Re: St. Lucie Plant Unit 2  
Docket No. 50-389  
Renewed Facility Operating License No. NPF-16

Response to NRC Reactor System Branch and Nuclear Performance Branch  
Request for Additional Information Regarding Extended Power Uprate License  
Amendment Request

**Response to Reactor Systems Branch and Nuclear Performance Branch  
Request for Additional Information**

Figure SRXB-78-1  
Reactor Coolant System Loop Sections

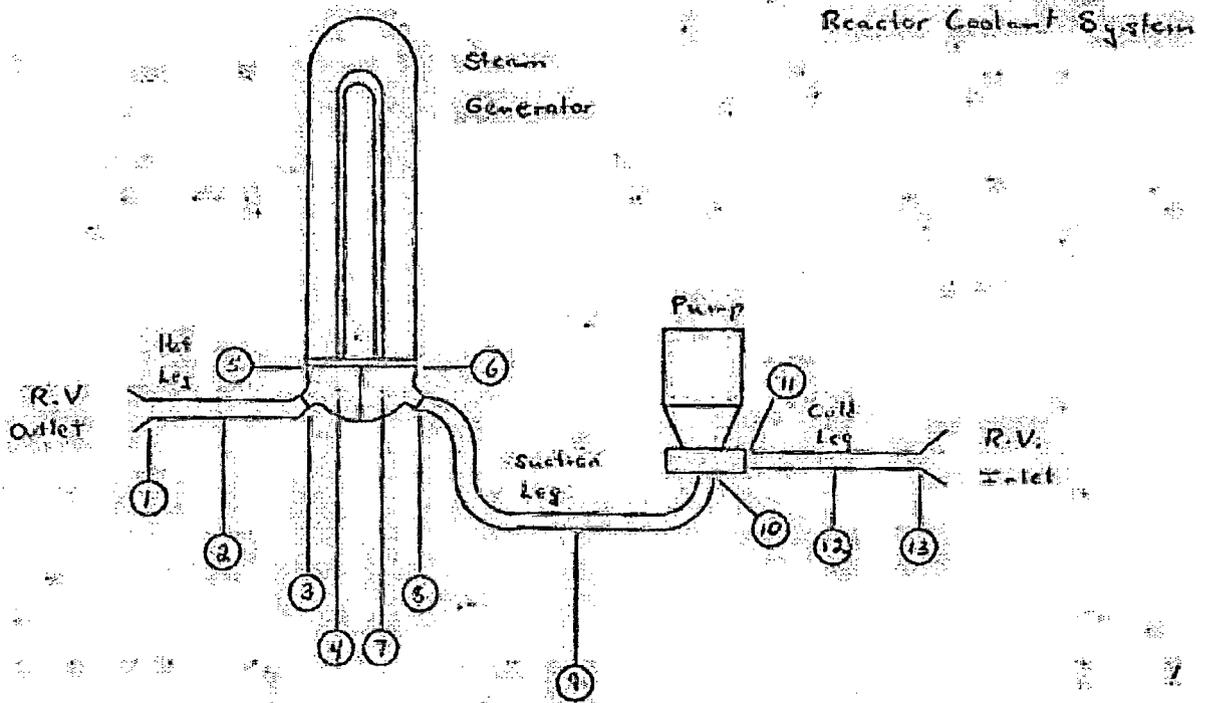
- a. Volume of the lower plenum, core and upper plenum below the bottom elevation of the hot leg, each identified separately. Also provide heights of these regions.
- b. Loop friction and geometry pressure losses from the core exit through the steam generators to the inlet nozzle of the reactor vessel. Also, provide the locked rotor RCP k-factor. Please provide the mass flow rates, flow areas, k-factors, and coolant temperatures for the pressure losses provided (upper plenum, hot legs, SGs, suction legs, RCPs, and discharge legs). Please include the reduced SG flow areas due to plugged tubes. Please also provide the equivalent loss coefficient through the loop to a break in the single broken cold leg. Also identify the flow area (hydraulic diameter) the k-factors are based on.

- b. The loop friction and geometry pressure losses are documented below in Tables SRXB-78-2 and SRXB-78-3, along with Figures SRXB-78-1 and SRXB-78-2, which are provided for informational purposes. Additionally, Table SRXB-78-2 and Figure SRXB-78-2 provide information on the reactor vessel, which was not specifically requested, but is provided for completeness.

**SRXB-81-1  
Void Fractions**

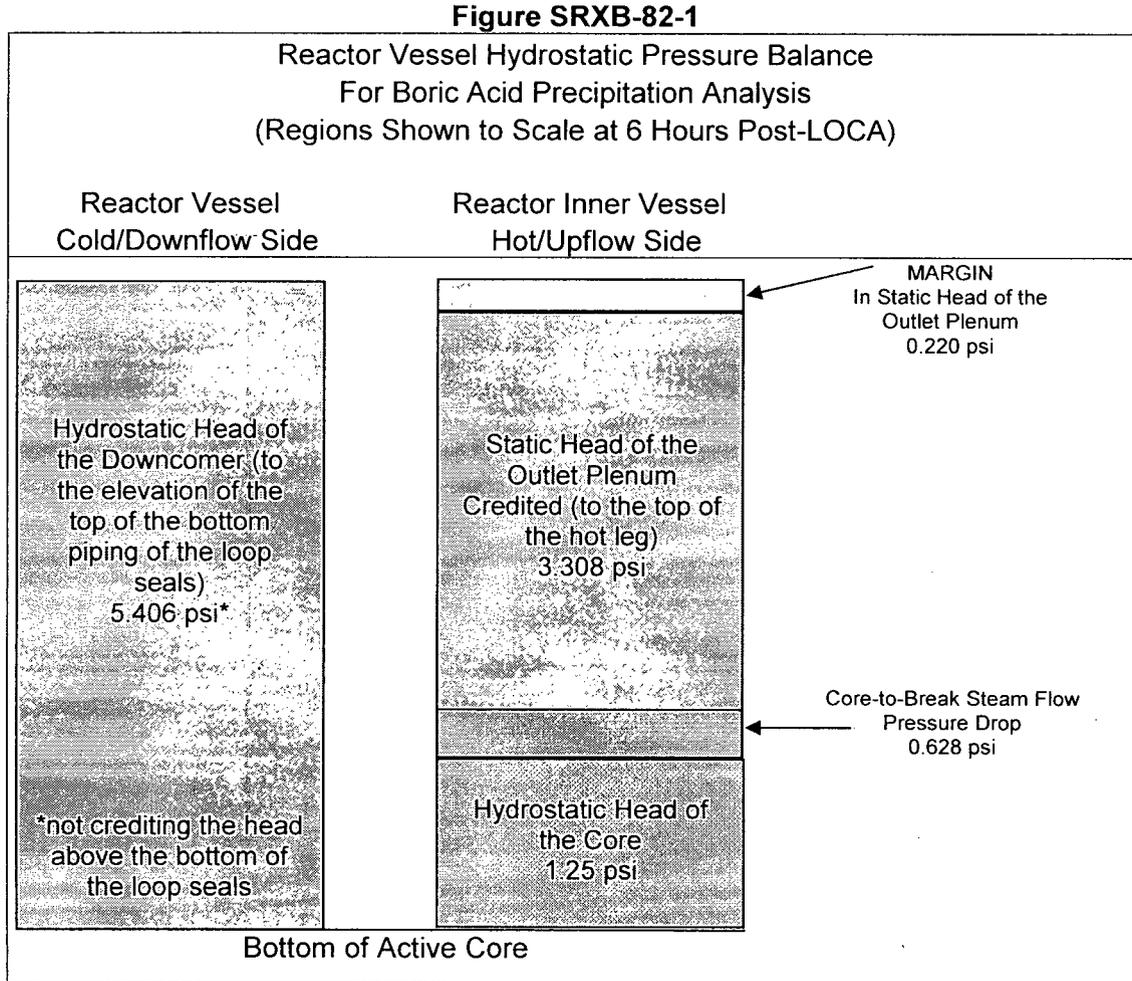
**Is the mixing volume assumed to be a fixed volume in the method? Since decay heat is higher early in the event, the loop pressure drop will be higher and limit the growth of the mixing volume with time from the initiation of the LOCA. As such, the mixing volume cannot be fixed (constant) parameter until hot side injection is aligned. Please explain. Also, please show the mixture height vs time and the core and upper plenum void distributions at one hr intervals until the switch to hot side injection is made?**

Regardless of time, the height of the outlet plenum credited for the mixing volume is assumed to be constant and credited to the top of the core support barrel nozzle (the outlet plenum height is 7.9620 feet). Table SRXB-81-1 documents the core and upper plenum void distributions for 1-6 hours.
